RE: Subdivision and Rezoning & Secondary Plan Amendment – Gunn Redonda [File No. DASZ 18/2014]

Transcona North Precinct

Land Use Concept

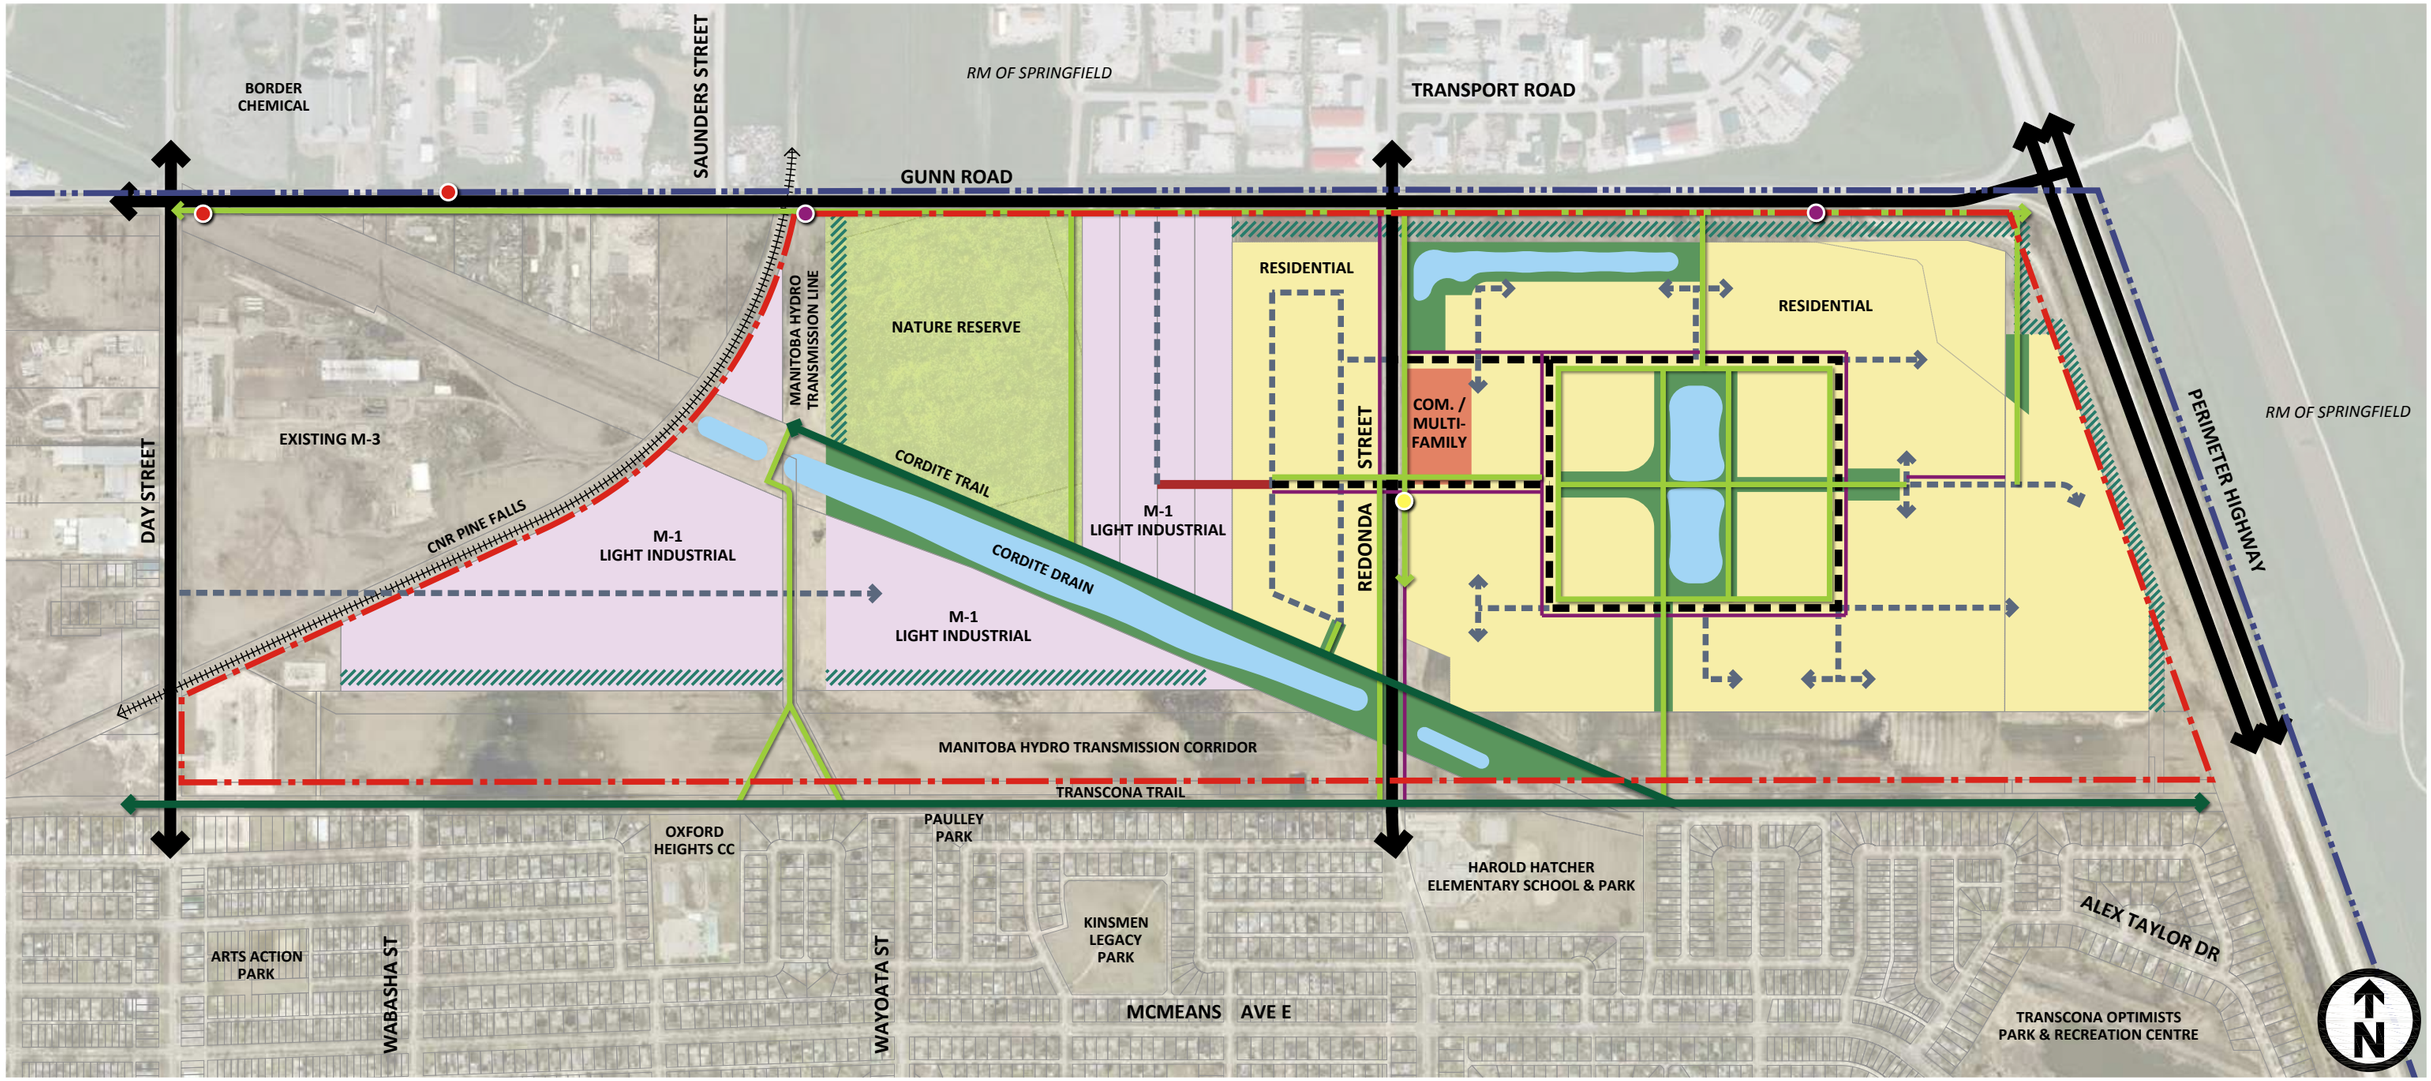
- Figures 3, 4, 7, and 8 will be consolidated into one Figure, Figure 3.
- Figures 6a and 6b will be removed.

- Table of Figures needs to be updated to reflect current figures as follows:
    - Figure 1: Precinct Plan Area
    - Figure 2: Property Ownership
    - Figure 3: Land Use Concept

- Figure 4: Gunn Road Buffer
    - Figure 5: Municipal Trunk Services
- Change all references to Figures 4, 7, and 8 to reference Figure 3.
- Change all references to Figure 5 to Figure 4.

Municipal Trunk Services

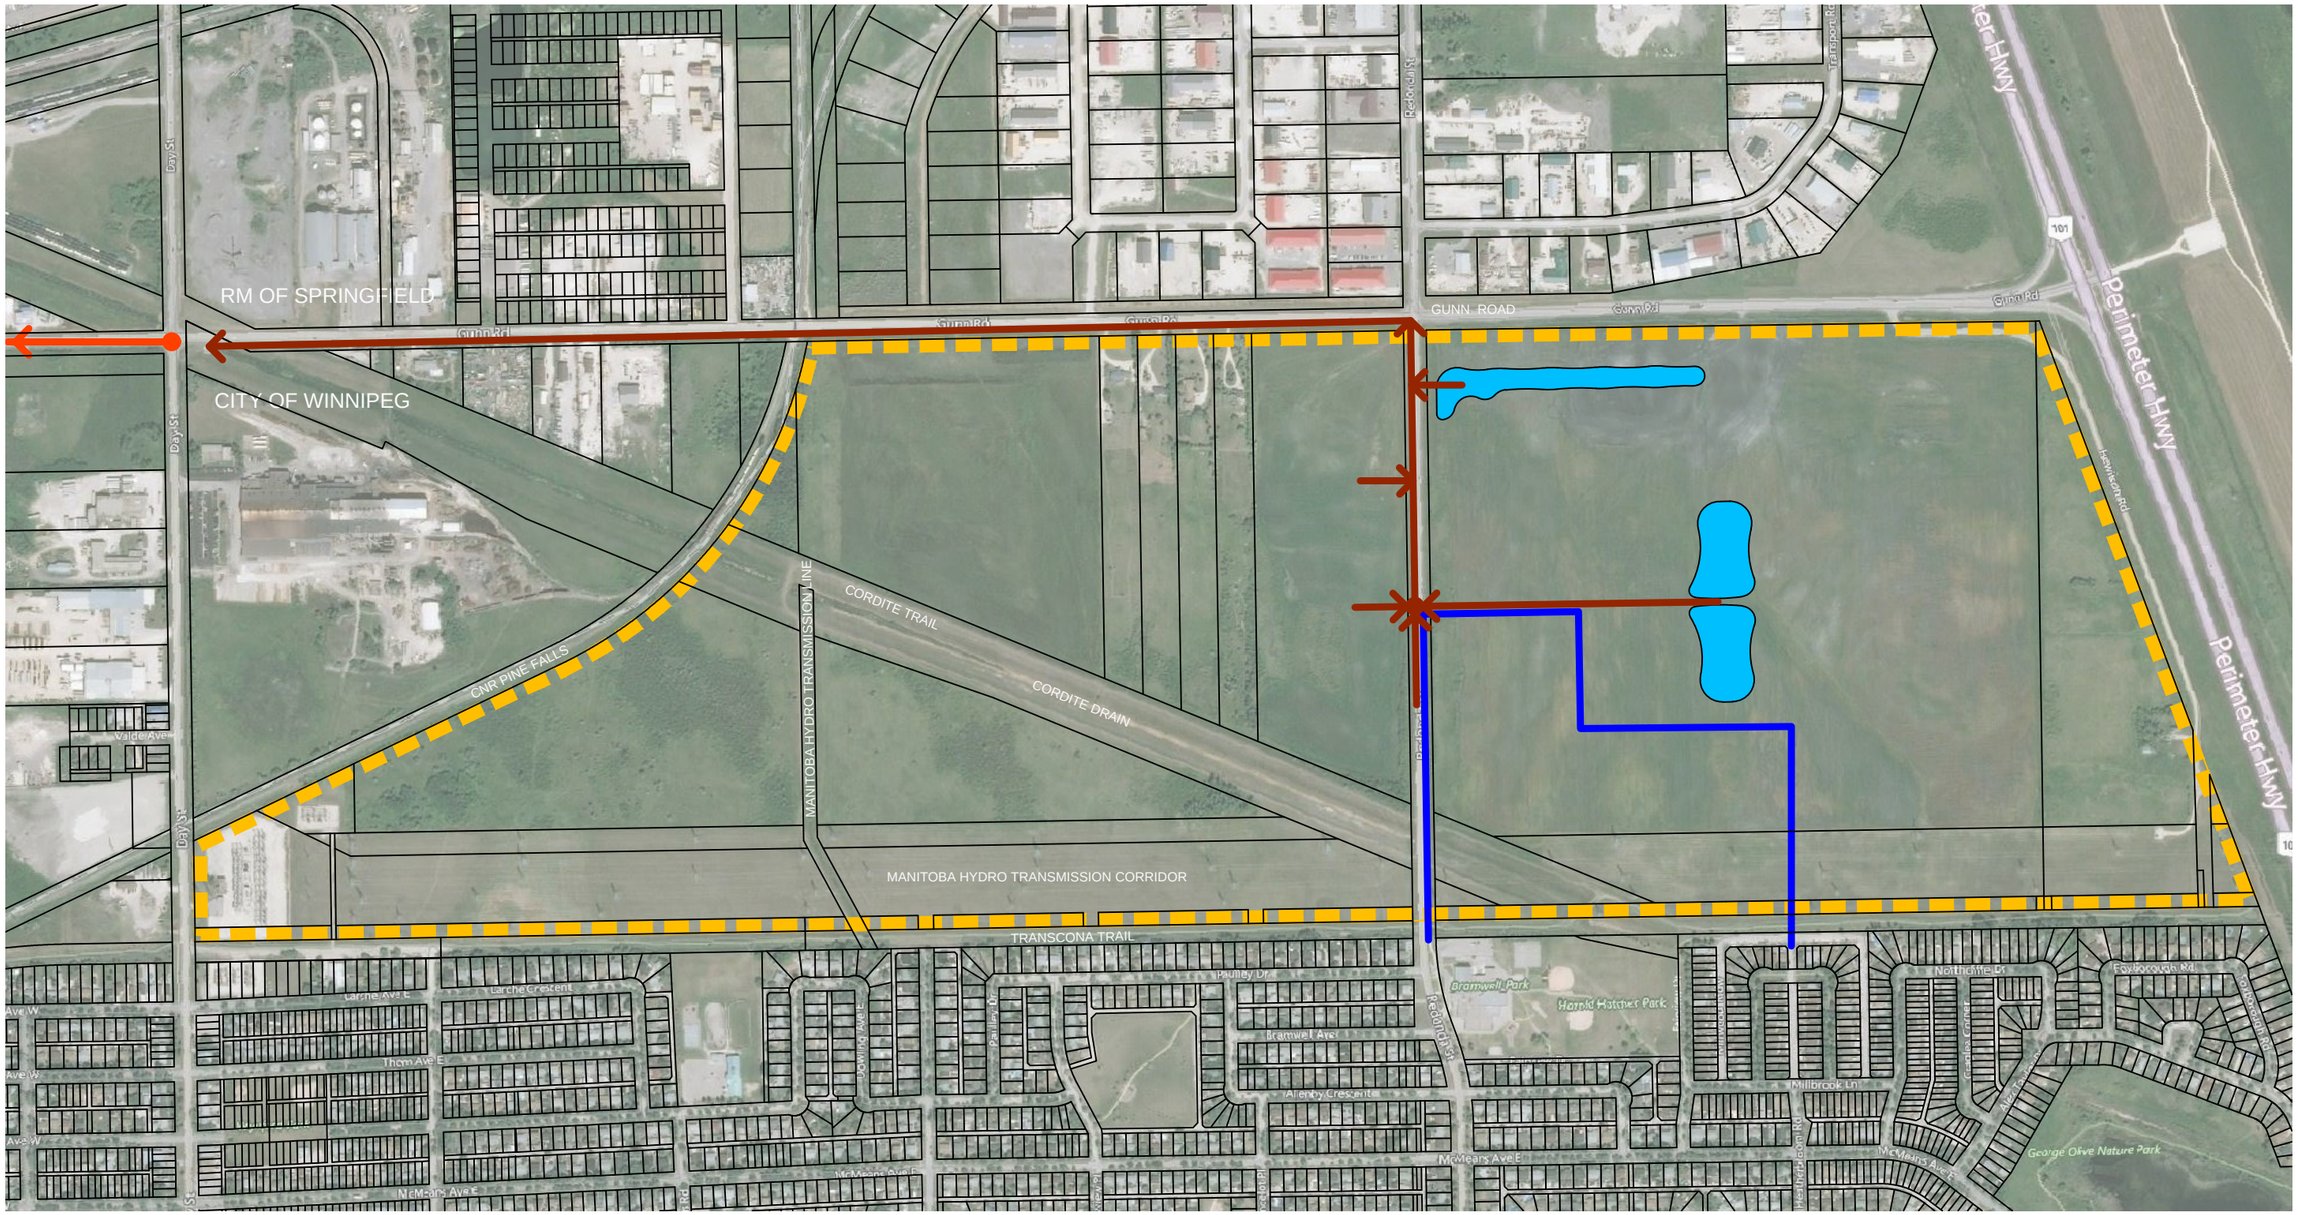
- Figure 9 will be revised to align with the proposed redesign.

- Change all references to Figure 9 to Figure 5.
- P.7 - Edit Property Ownership Figure to change North Grassie Properties Lands to Private Landowner 1 (or 8) and change remaining Private Landowner references accordingly.
